Title: Approve preferred alternative - Cedar Lake Road/ Louisiana Avenue Improvements (4023-1100, 4024-1100) – Ward 4

Recommended action: Motion to adopt Resolution granting approval of the preferred alternative for the Cedar Lake Road Reconstruction project and the Louisiana Avenue Reconstruction project.

**Resolution supporting the preferred
alternatives for the Cedar Lake Road Reconstruction Project and the
Louisiana Ave Reconstruction Project
Projects No. 4023-1100 and 4024-1100**

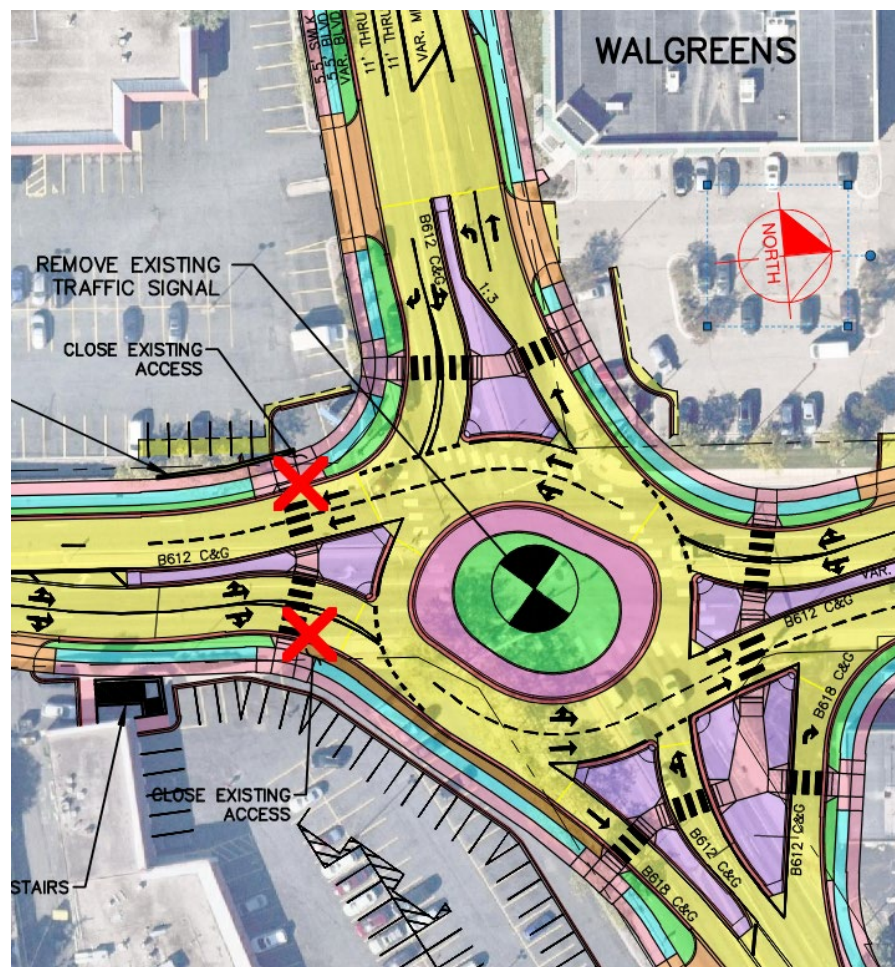
5. Will a roundabout be safe with the existing hill along Louisiana Avenue between Cedar Lake Road and the railroad bridge?

The construction of a roundabout in this intersection does not change the slope of the hill from the Louisiana Railroad Bridge to the intersection of Cedar Lake Road and Louisiana Avenue. Also, the speed of vehicles navigating a roundabout will be slower, thus providing a safer intersection.

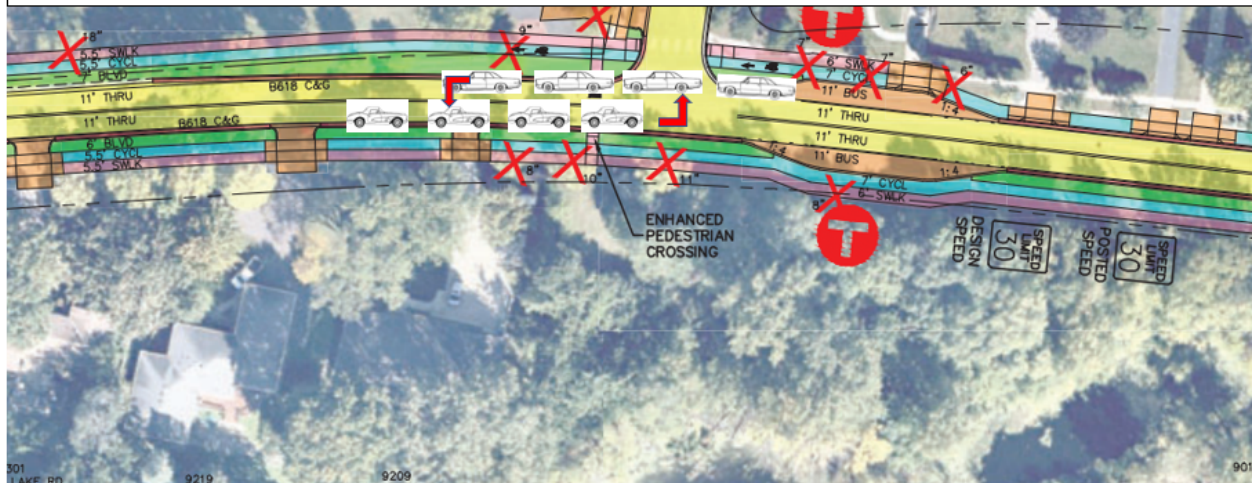
We know the engineering team doesn't believe the redesign is a problem, but driveway access is already an issue for us today. We are very pro sidewalks/bike lanes. It's one of the reasons we have lived here for 9 years. But, we also believe it's not unreasonable to make a small adjustment to the plan to allow access to our driveway during rush hour traffic.

Today, it is very difficult for us to enter our driveway during rush hour. The proposed plan will create additional challenges because it removes the turn lane from Cedar to Flag. The turn lane is critical because it allows through traffic heading east to continue down Cedar when there is an eastbound car taking a left onto Flag. There is a significant amount of traffic that uses this intersection to enter this part of Cedar Manor as it is the main thoroughfare to the many residences in that part of the neighborhood, and is also the main road that leads to the Minneapolis Golf Club.

Having this turn lane effectively allows traffic to not stack up in front of our driveway and block access to it when we are traveling westbound on Cedar and attempting to take a left into our driveway. The redesign will force all eastbound CLR traffic to *completely* stop if a single car is turning left onto Flag. In this scenario, if we are going westbound and have vehicles behind us when attempting to take a left turn into our driveway (which we frequently do) it will result in cars blocking access to Flag (see diagram below).

This creates a stalemate, and our options will be to 1) abandon our turn and continue westbound and then attempt a U-turn down the road, or 2) hold up traffic until the eastbound driver attempting to turn onto Flag gives up and abandons their left turn and continues east onto CLR so eastbound traffic flows again. Neither are ideal scenarios when there is plenty of room to solve for this when this project is a full redesign rather than a retrofit. The engineering team believes this is an uncommon occurrence, but it already happens to us multiple times a week *with* the turn lane in place. All we want is enough room for through traffic on Cedar to be able to pass a car turning onto Flag. This avoids a stalemate, and we can eventually enter our driveway. All that is lost is a tiny amount of green space if a turn lane were preserved, or if a wide shoulder in either direction were in its place so cars could pass by when somebody is turning onto Flag. Please help.

15. Why is the eastbound left turn lane along Cedar Lake Road at Flag Avenue being removed?

This turn lane is being removed to prioritize pedestrian and bicyclist access along Cedar Lake Road. The benefits of removing the turn lane include the following:

- Shorter pedestrian and bicyclist crossing of Cedar Lake Road (crossing two lanes of traffic vs. crossing three lanes of traffic).
- The crossing of Cedar Lake Road at Flag Avenue is the closest crossing to the Park Spanish Immersion School. This crossing is being enhanced with a rectangular rapid flashing beacon. Users could also cross at the traffic signal at Jordan Avenue.
- Reducing the width of the road helps reduce vehicle speed along Cedar Lake Road.
- Less right of way impacts to adjacent private property.
